Duane Arnold

Furnishing Response To Request For
Additional Information Related to
Potential RHR Pump Runout Conditions.

REQUEST FOR ADDITIONAL
INFORMATION RELATED TO
POTENTIAL RHR PUMP
RUNOUT CONDITIONS

Docket # 50-331

(FIGURE-1)

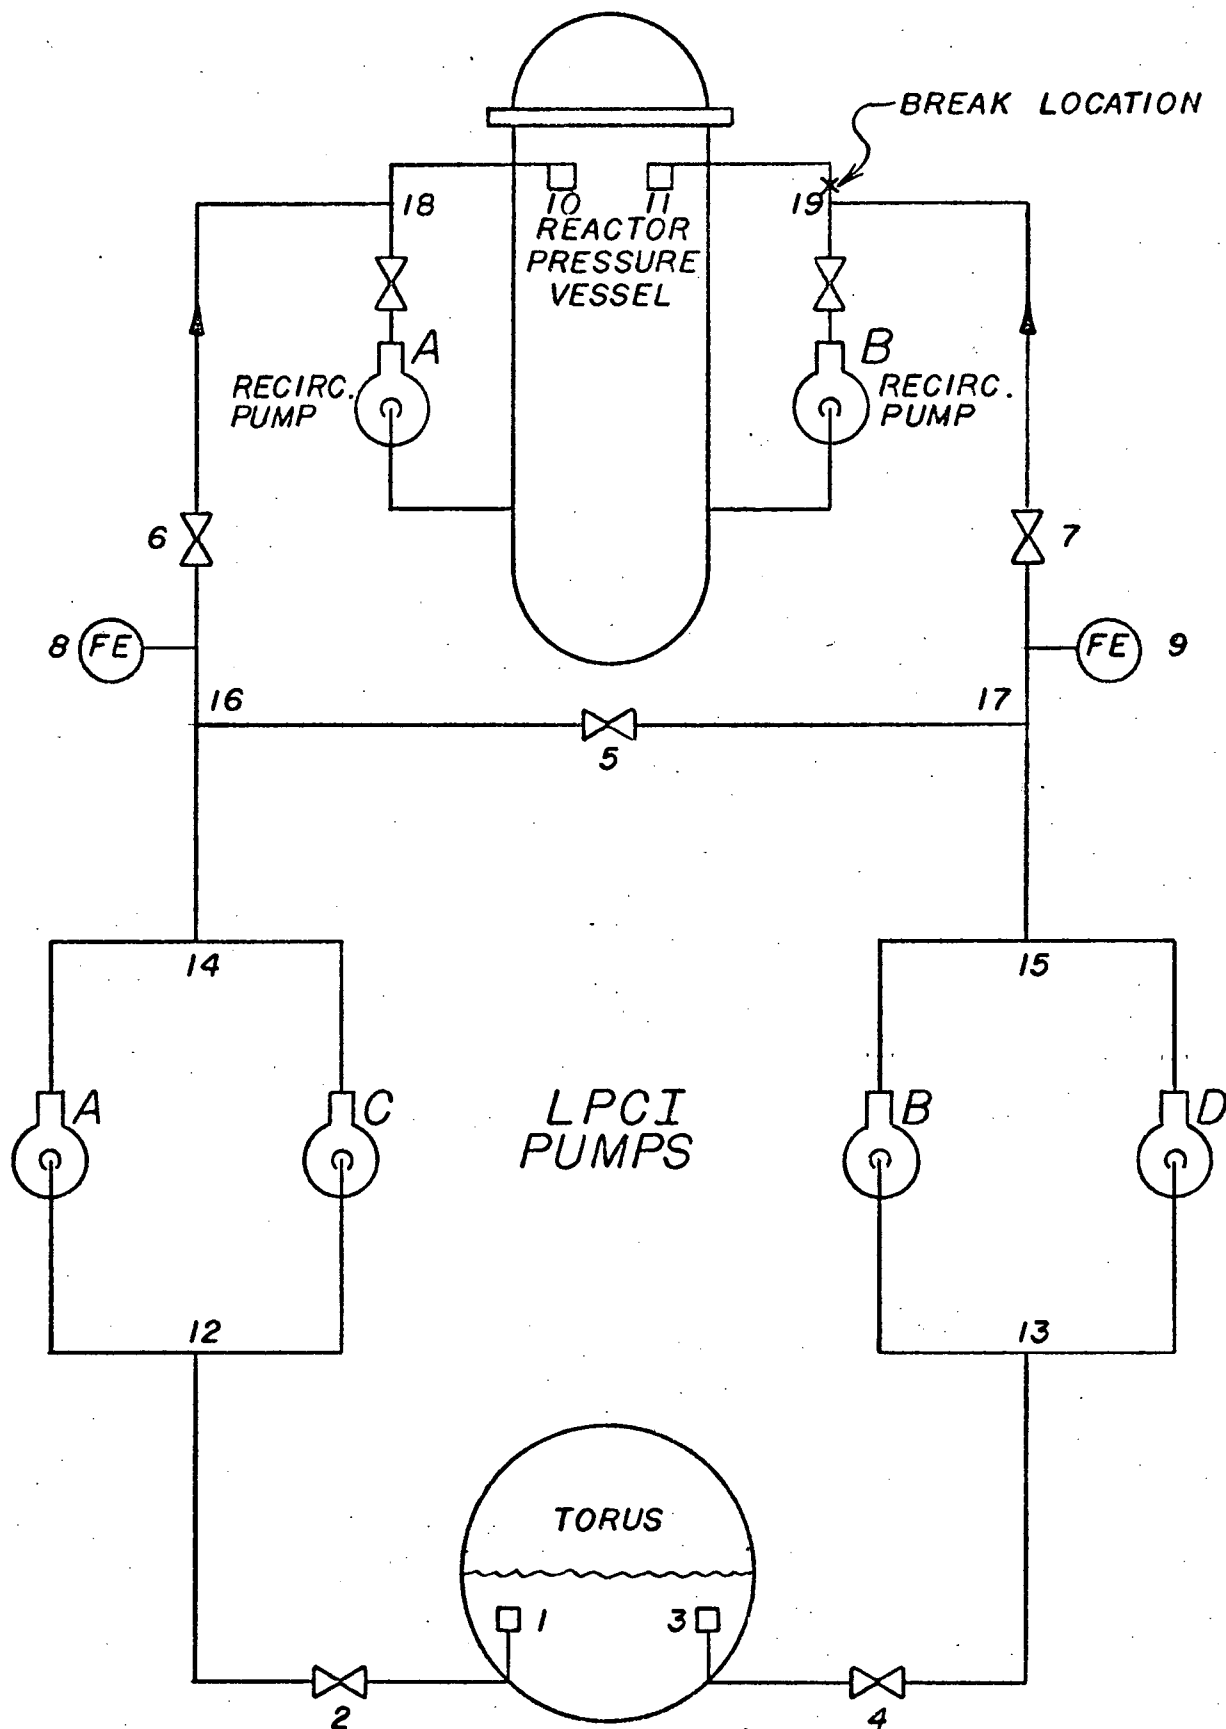
- 1) What break location was assumed when evaluating the maximum flow possible from a LPCI pump or pumps pumping directly to a break? Describe how the system losses were calculated, including a sketch of the system assumed and a tabulation of the head loss in feet for each component in the system (valves, orifices, heat exchangers, etc.).

- 1) In condition (1) and (2), as listed in Reference (2), the recirculation line break was assumed to be located at the point where the RHR injection line intersects the reactor recirculation line to minimize flow resistance. In condition (3) listed in Reference (2) the LPCI pumps were directed to this intact reactor recirculation line. The break location in this case was assumed to be between the reactor vessel and the reactor recirculation pump to maximize the effects of a postulated Loss-Of-Coolant-Accident.

The assumptions used in calculating RHR system losses maximized system resistance in the LPCI pump suction lines and components and minimized system resistance in the LPCI pump injection lines. This maximized the potential for LPCI pump runout and minimized the Net Positive Suction Head (NPSH) available to the LPCI pumps.

The system configuration for the above three conditions are shown in Figures 1 and 2. The RHR system losses, in equivalent feet of head, for each component are tabulated in Table 1. The flow paths in the RHR system were selected to minimize system resistance in the LPCI pump injection lines and minimize NPSH available to the pumps. In calculating system resistance no credit was taken for static head in reactor vessel during reflooding following a postulated LOCA.

All piping, valves and fittings in the A and B reactor recirculation loops were conservatively neglected in all system head loss calculations.
